ADDENDUM NO. 1

Plans & Specifications for: Elsie Turner Field & Graverson Playground, Waltham, MA

In accordance with documents prepared by: Carolyn Cooney & Associates

**GRADING & DRAINAGE
PLAN**

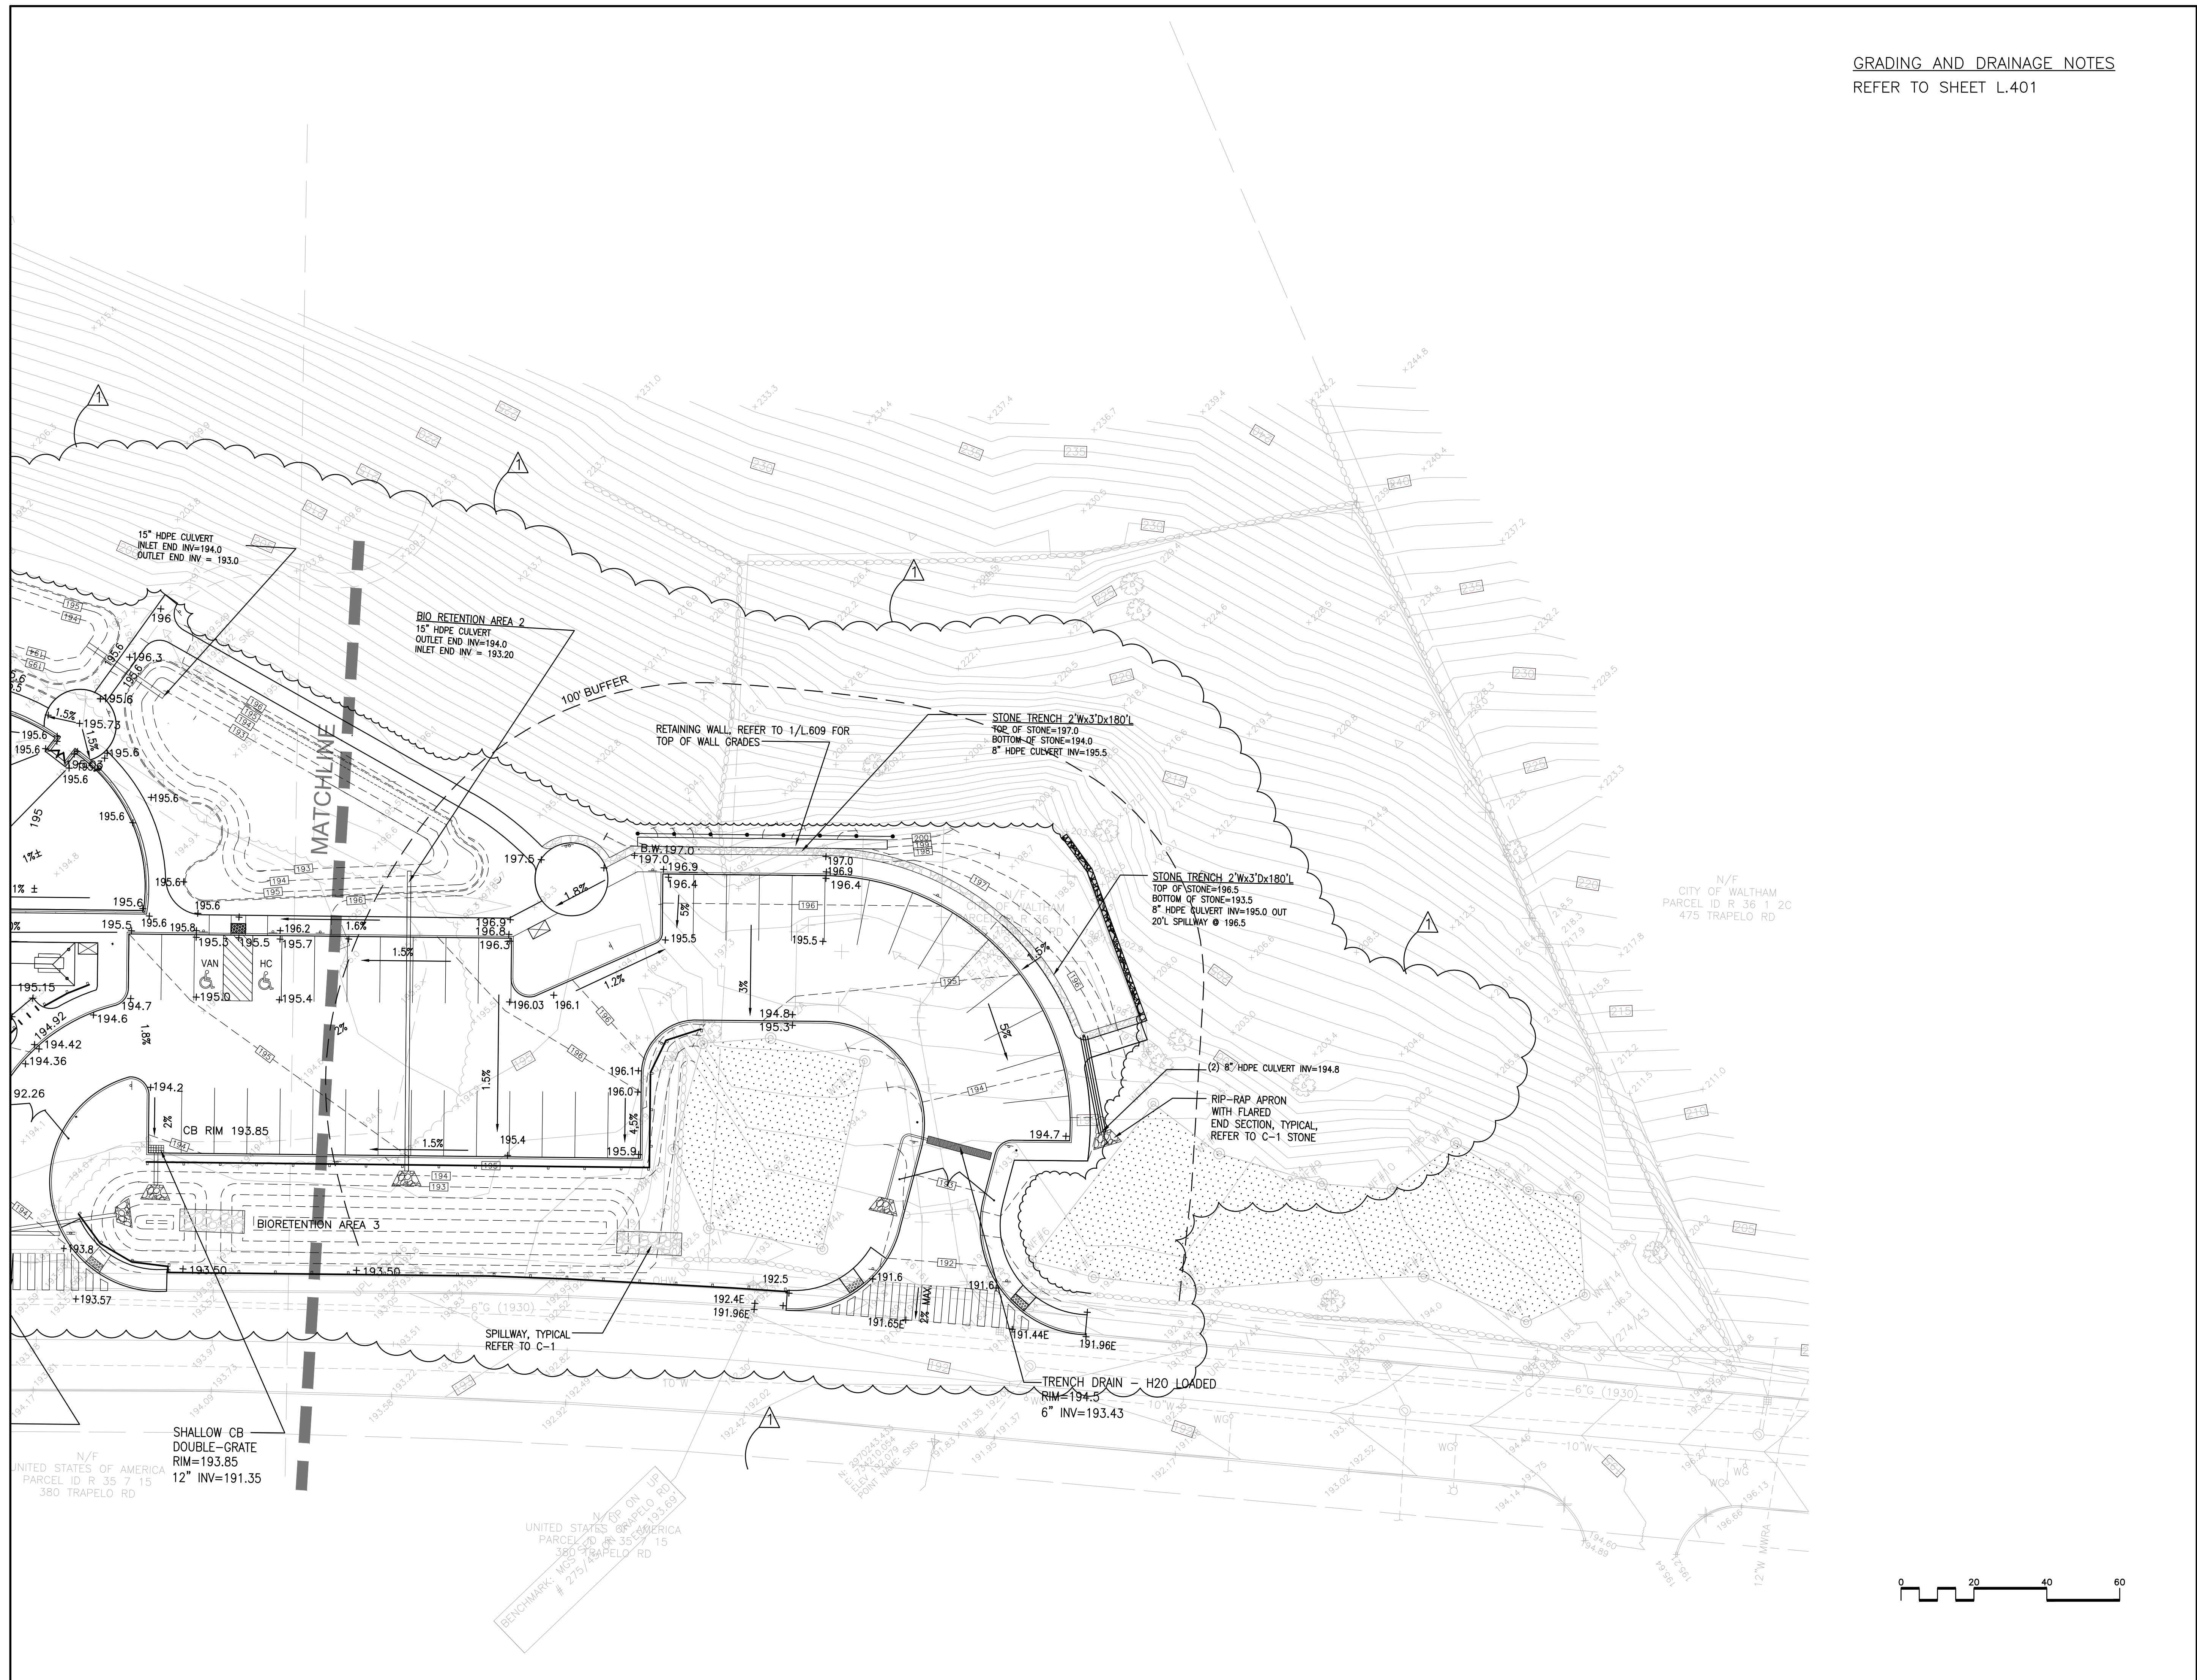
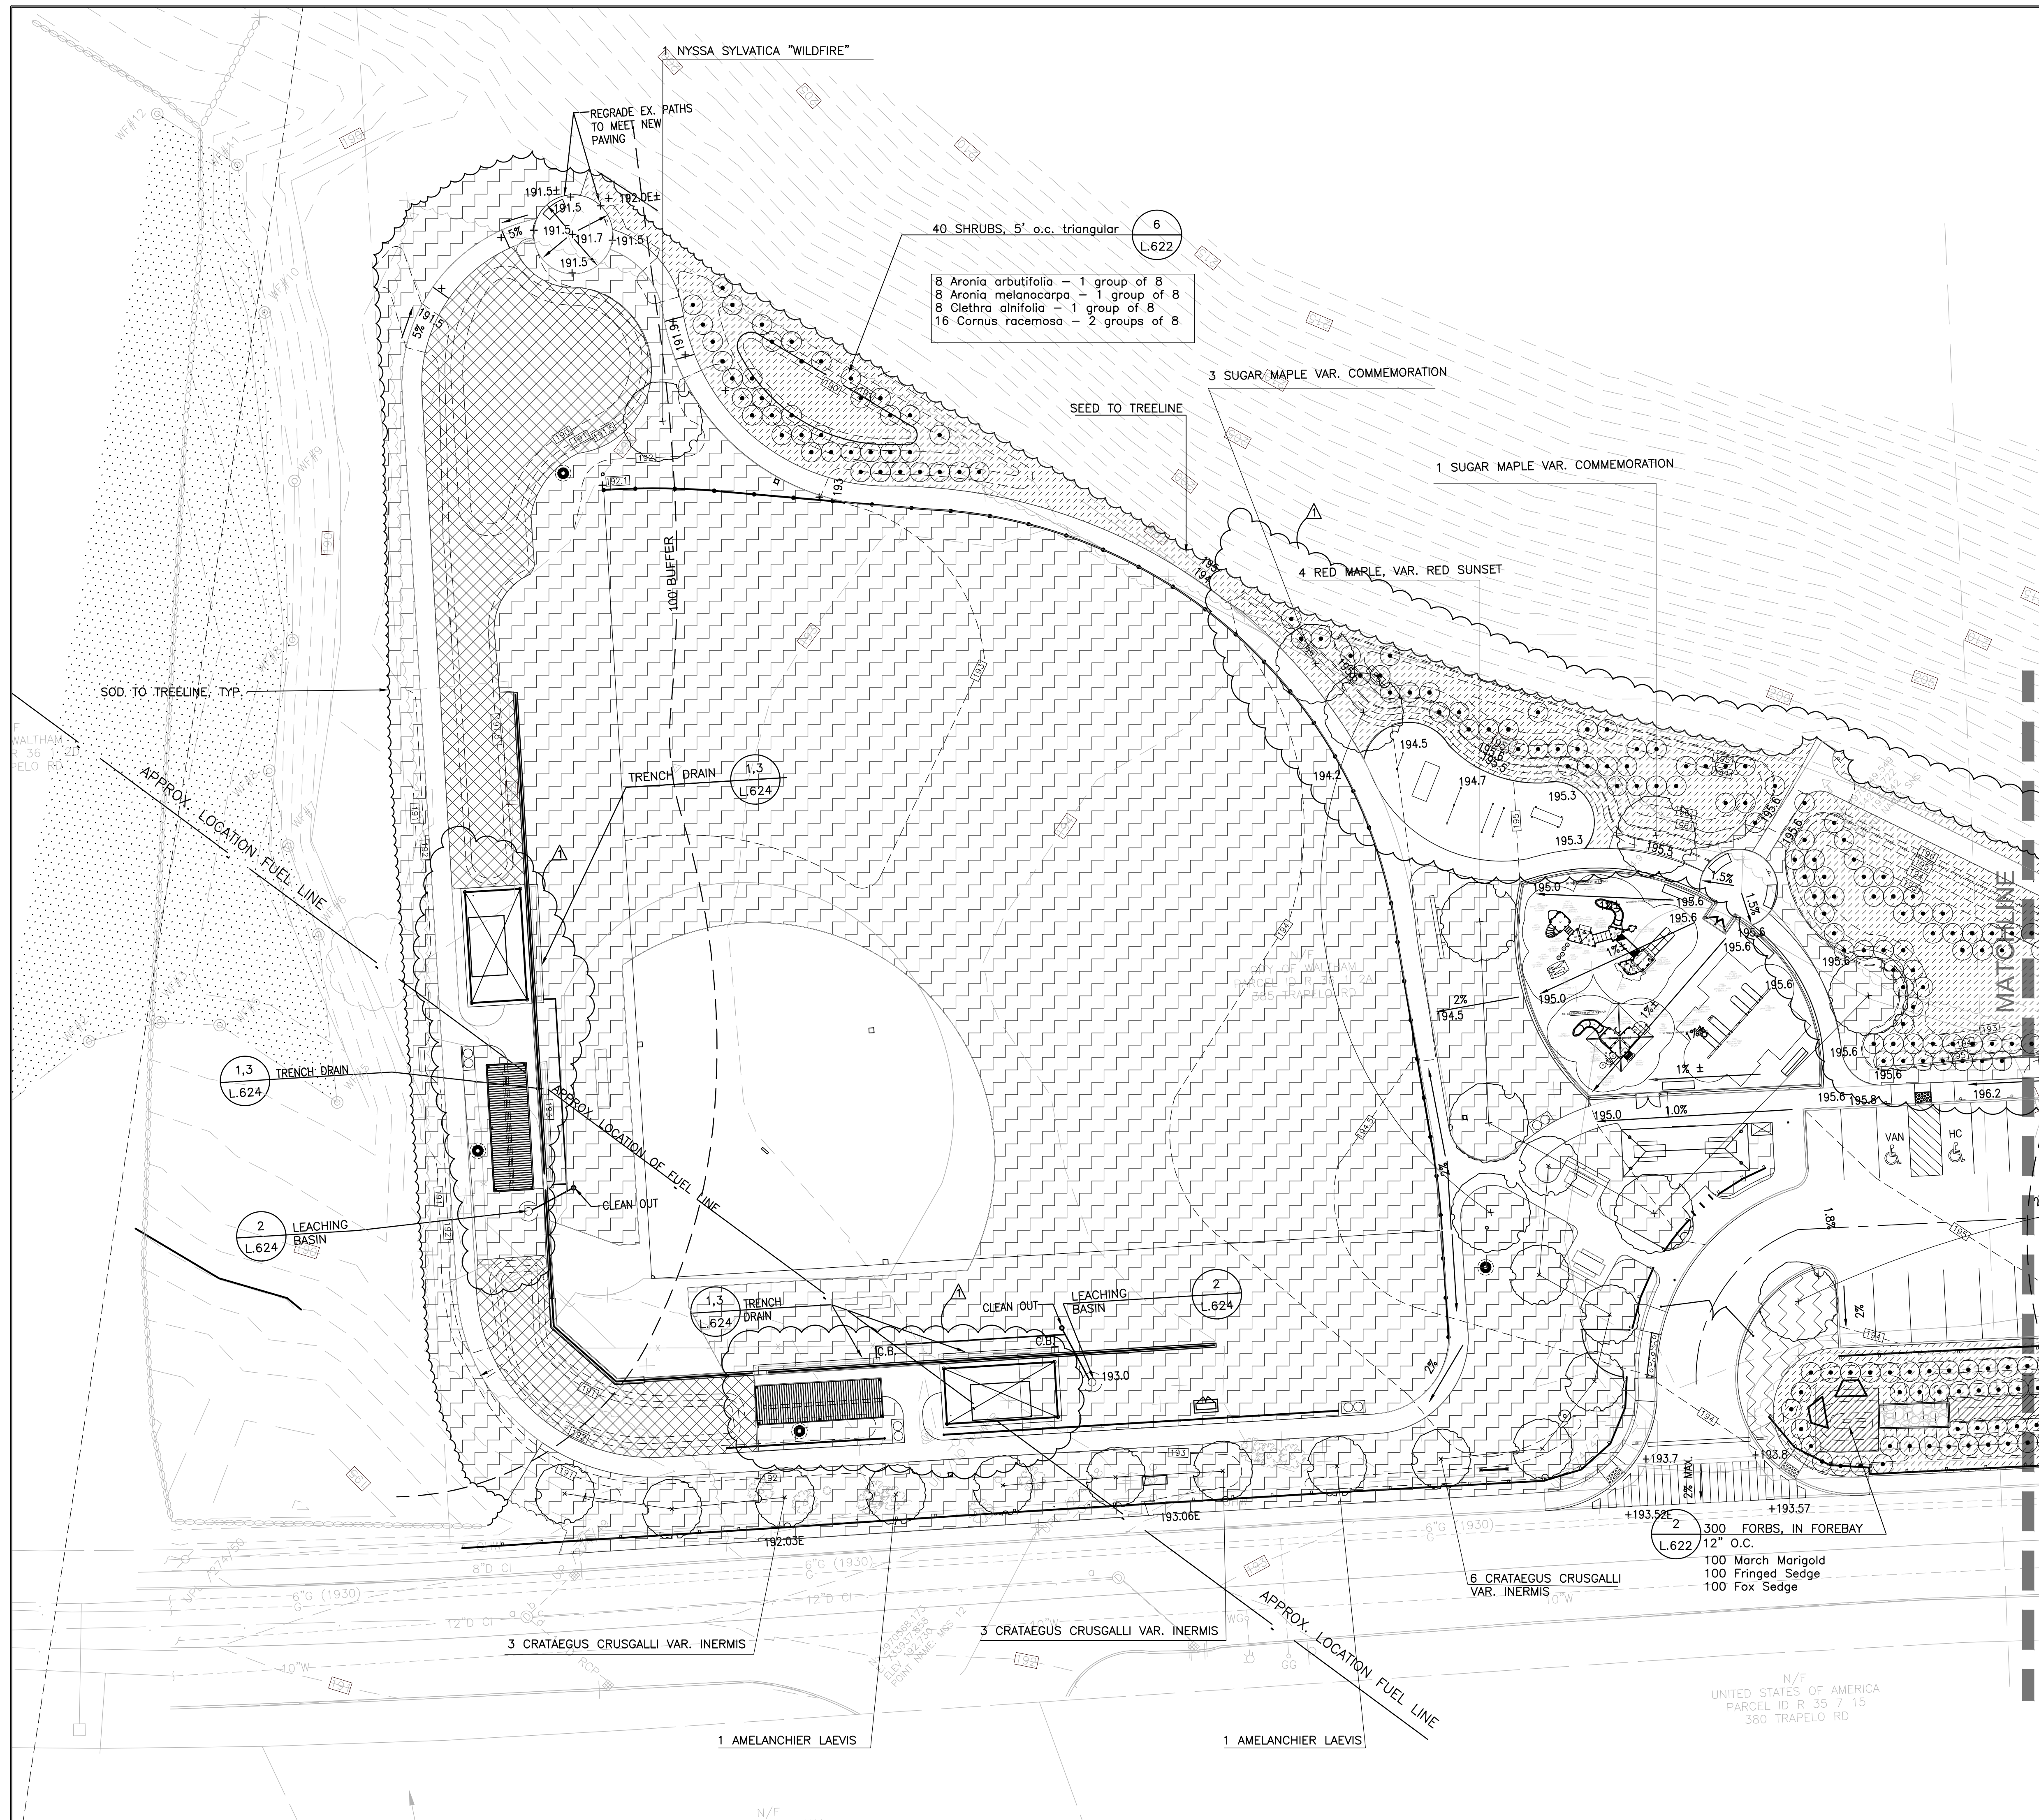
- ITEM NO. 15** *Elsie Turner Field: Replace Drawing L.301 and L.302 with new Drawings L.301 and L.302 attached.*
- ITEM NO. 16** *Elsie Turner Field: Replace Drawings L.401 and L.402 with new Drawings L.401 and L.402. Revision is to field grading, parking lot grading, and height of wall at parking lot.*

TITLE:
PLANTING PLAN

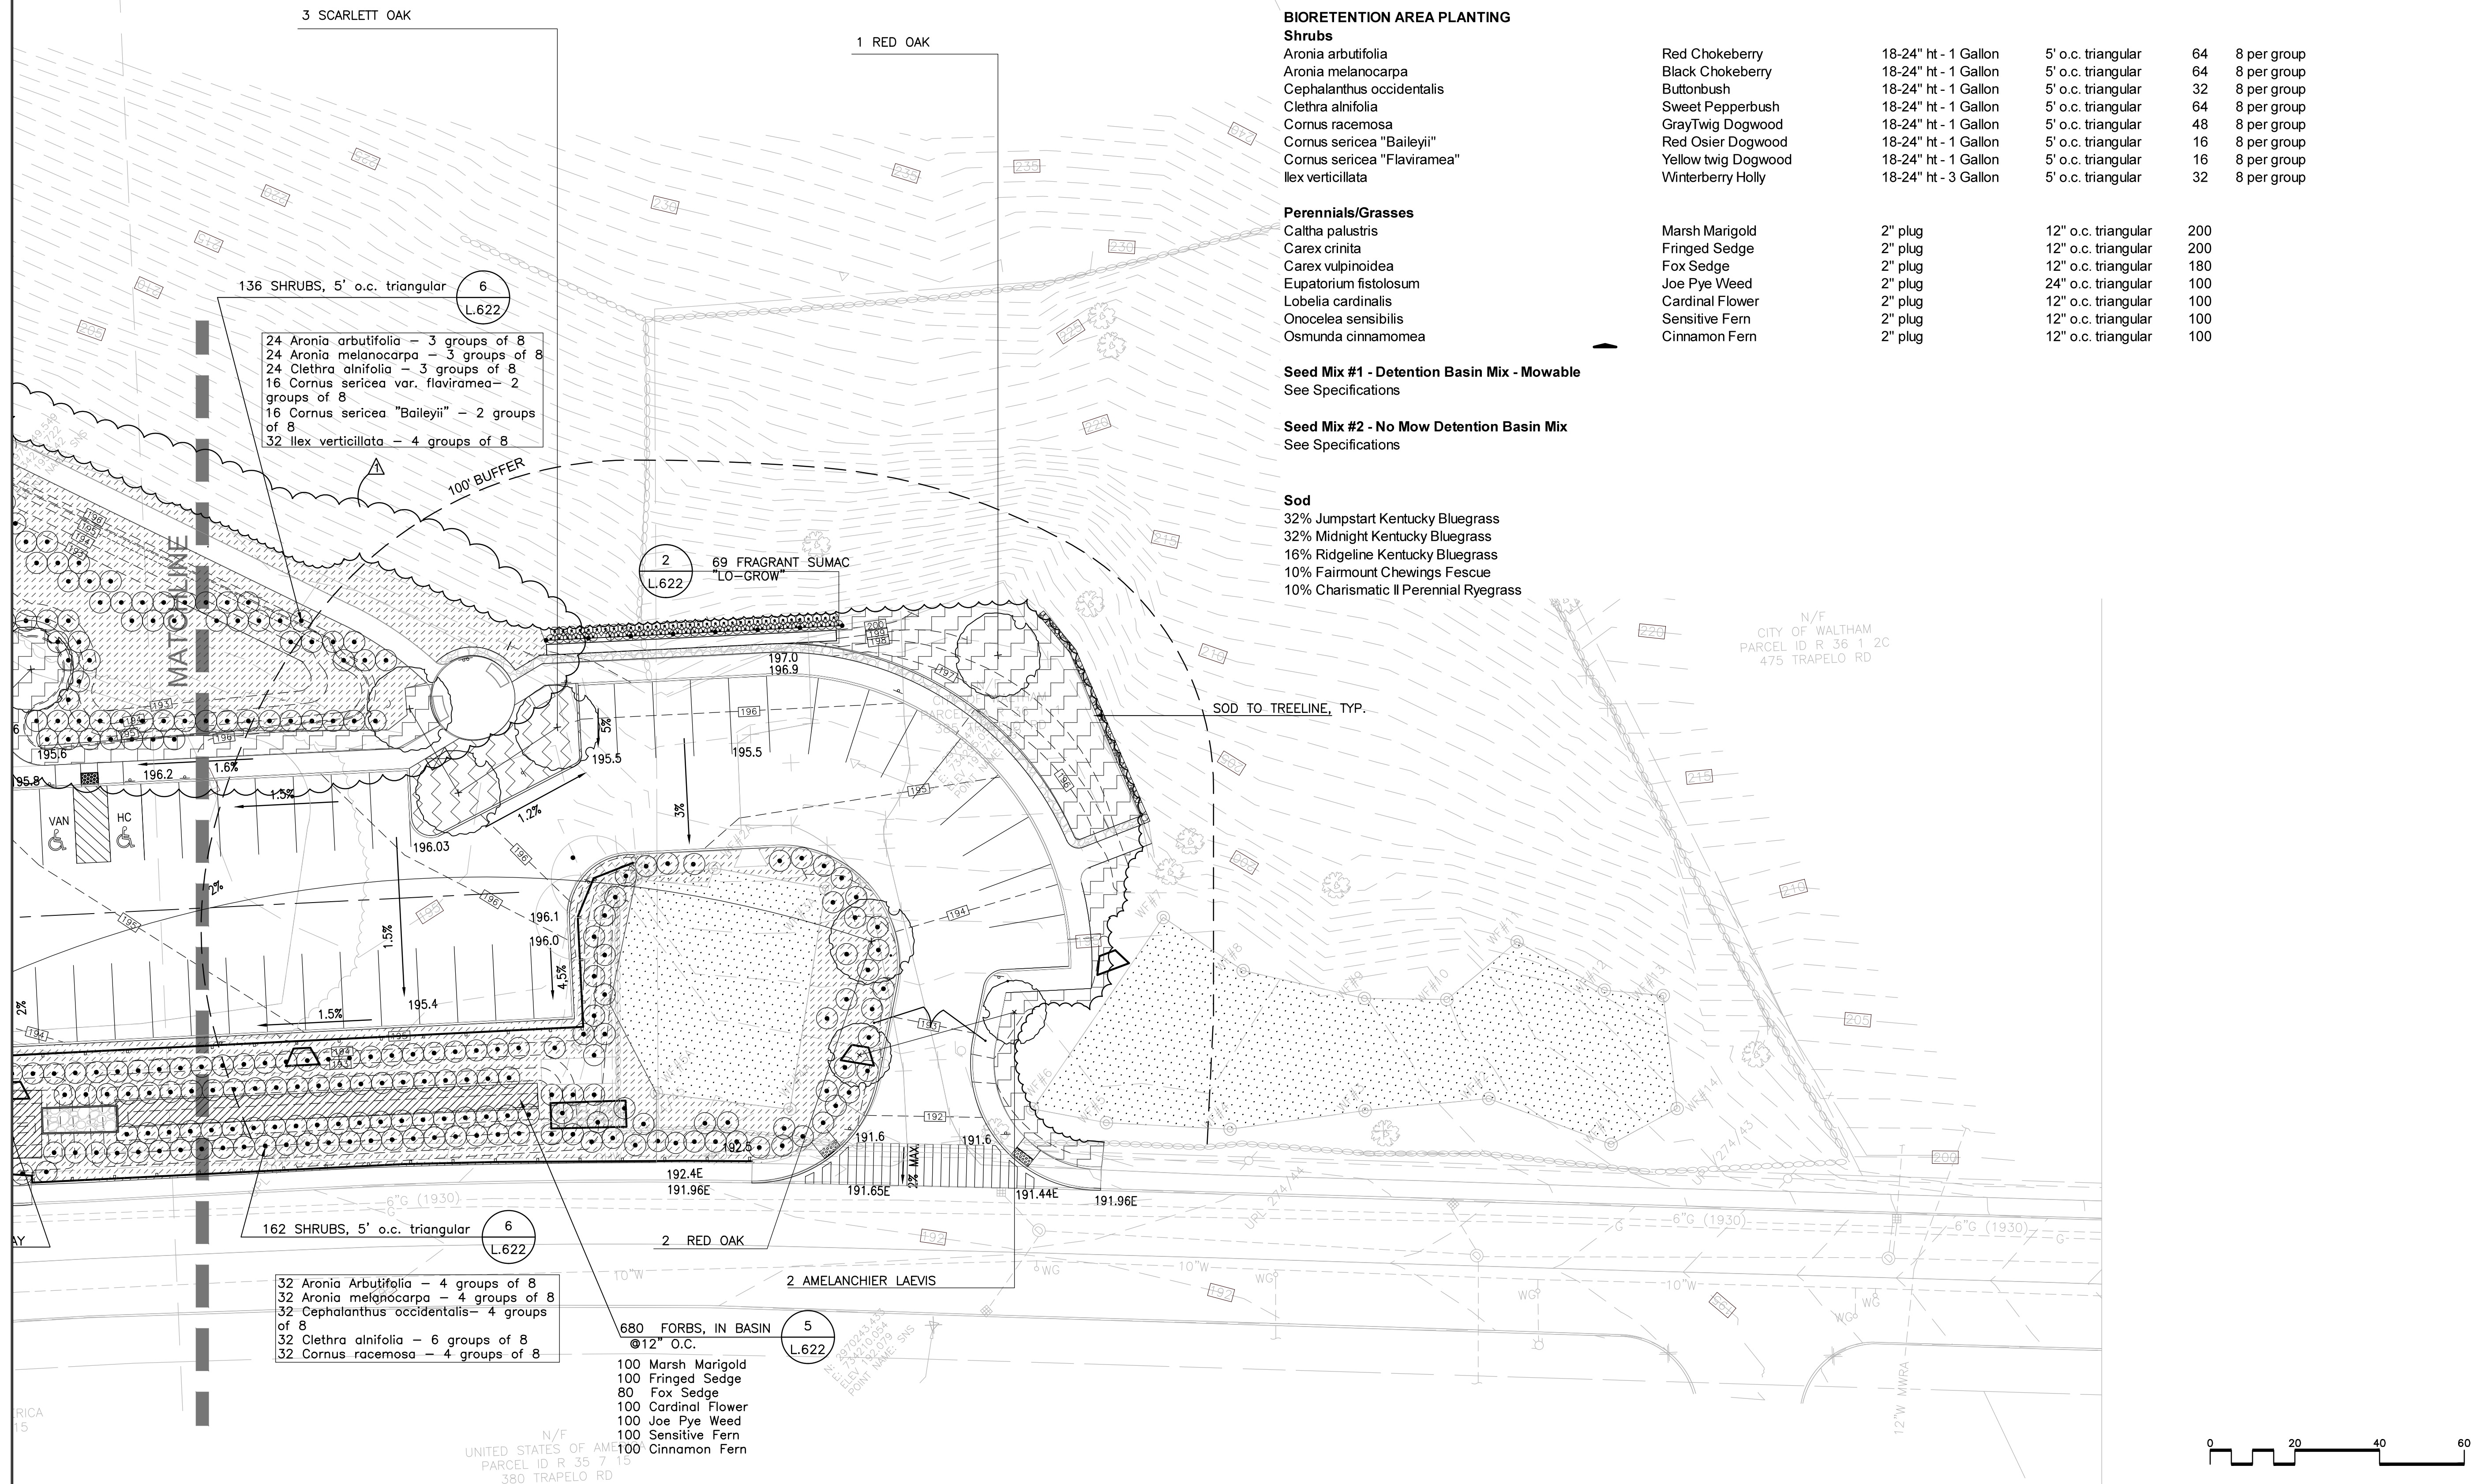
- ITEM NO. 17** *Elsie Turner Field: Replace Drawings L.501 and L.502 with new Drawings L.501 and L.502. Revision is to areas of sod and seed related to changes in plan at Softball field and Bioretention area No. 2.*
